ADDENDUM NUMBER 02

PROJECT: The Salvation Army - Niles

PROJECT NUMBER: 23-0578

ARCHITECT: Abonmarche
315 W. Jefferson Blvd.
South Bend, IN 46601

SHEET TITLE:
EXISTING CONDITIONS

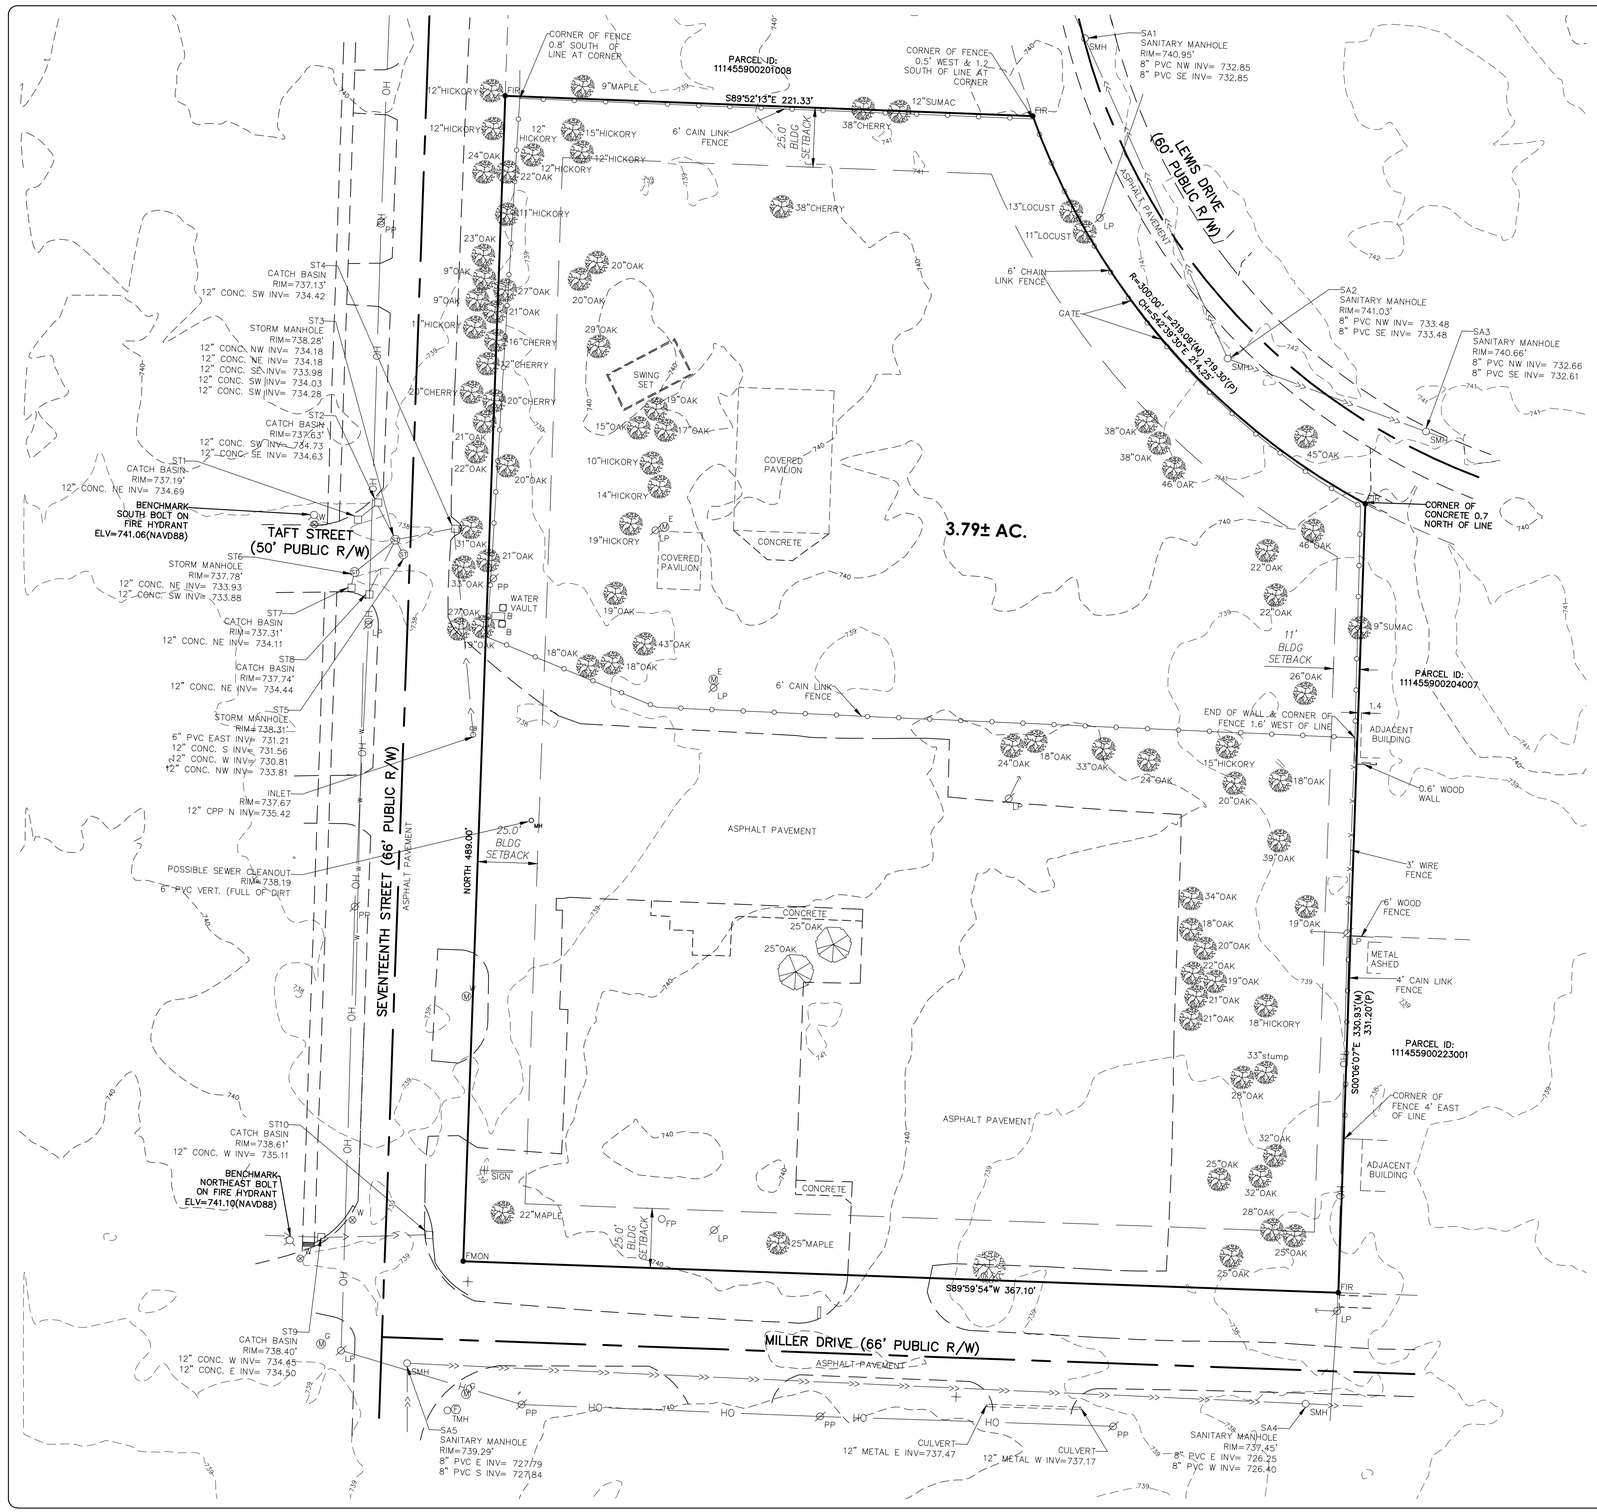
20. Increase size to the drainage basin
21. revise inverts
22. **ADD** fire hydrant an dipping across South 17th Street
23. Relocation of inlet structure at northwest drive.
24. **DELETE** tree at southeast existing drive entrance.

ROOF FRAMING PLANS

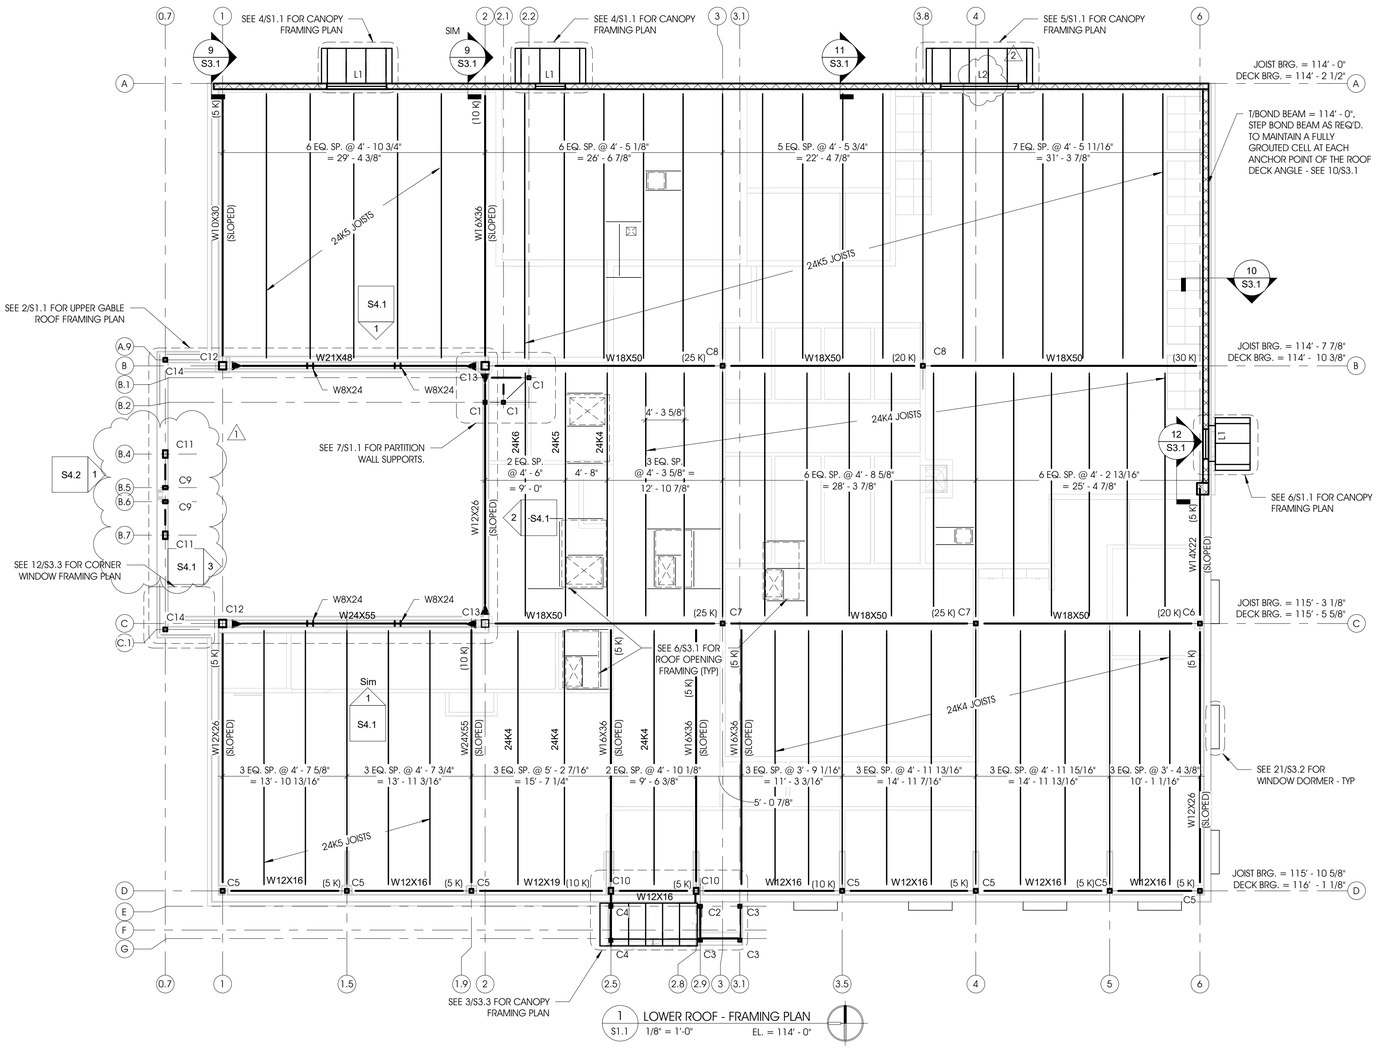
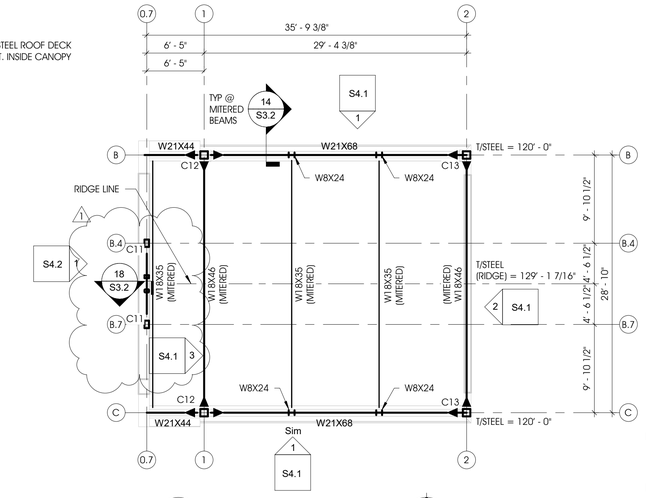
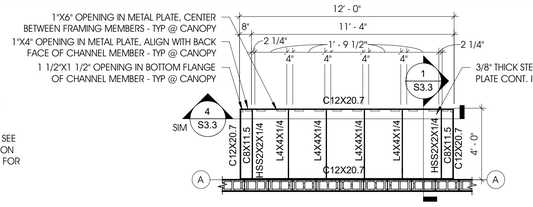
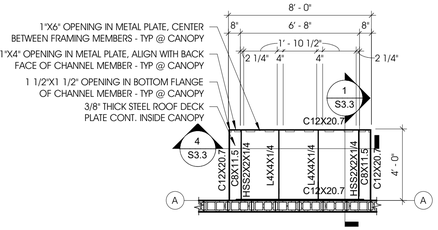
25. Update lintel plan and lintel by grid 4

7 S4.1 ENTRANCE ELEVATION - GRID 2.8
1/4" = 1'-0"

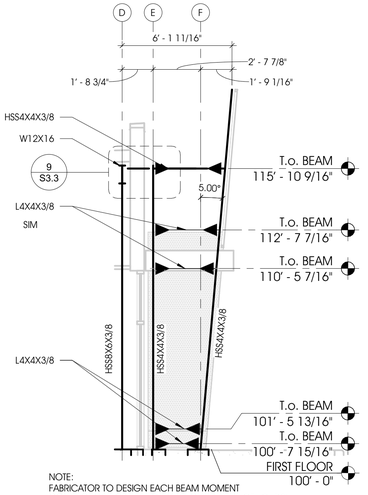
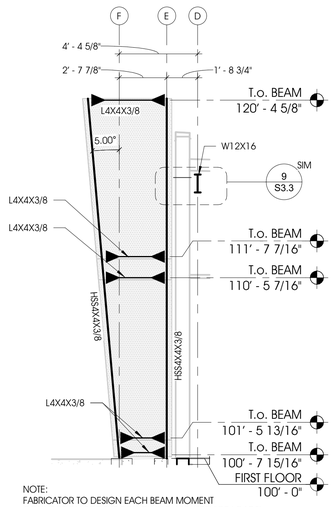
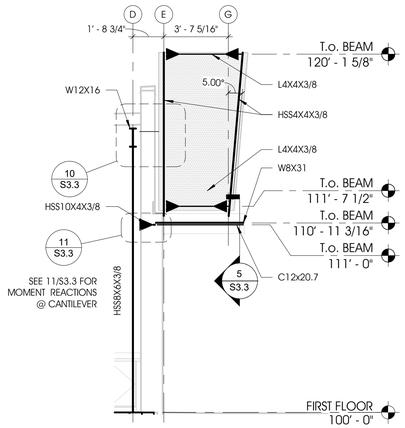
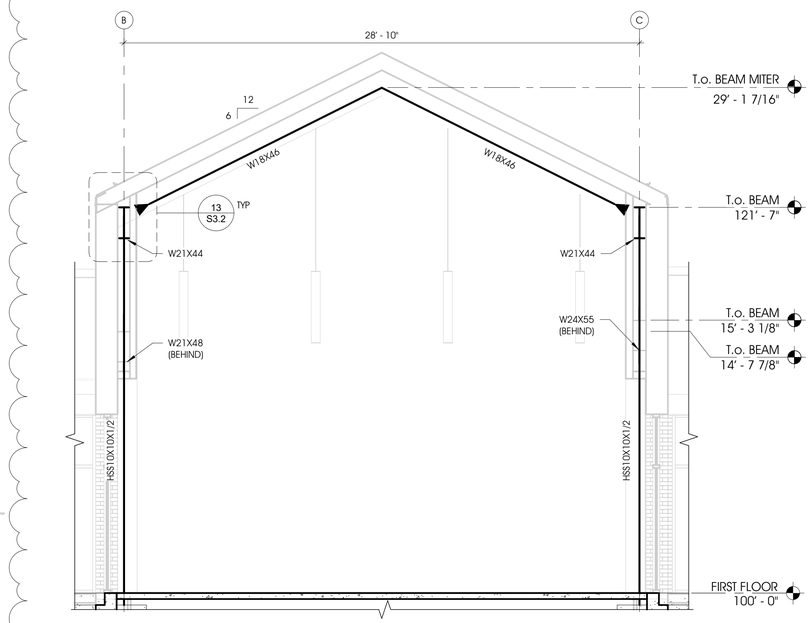
27. **ADD** galv. Note to 4,5,6,7/S4.1

SHEET TITLE:
FIRST FLOOR - REFLECTED CEILING PLAN

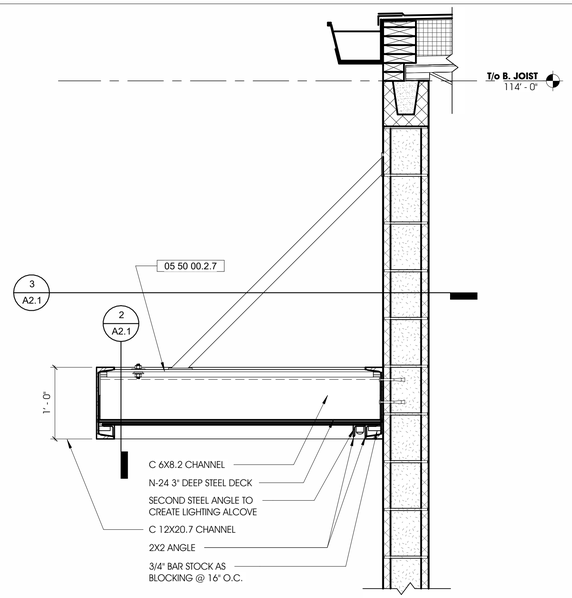
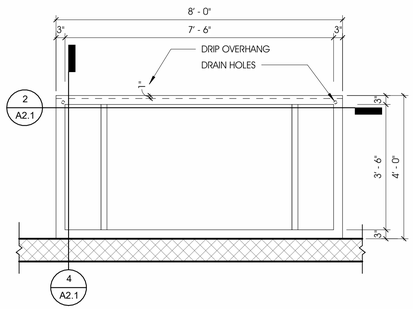
29. REVISE Chapel lighting layout.
30. REVISE Lighting Legend for fixture L17
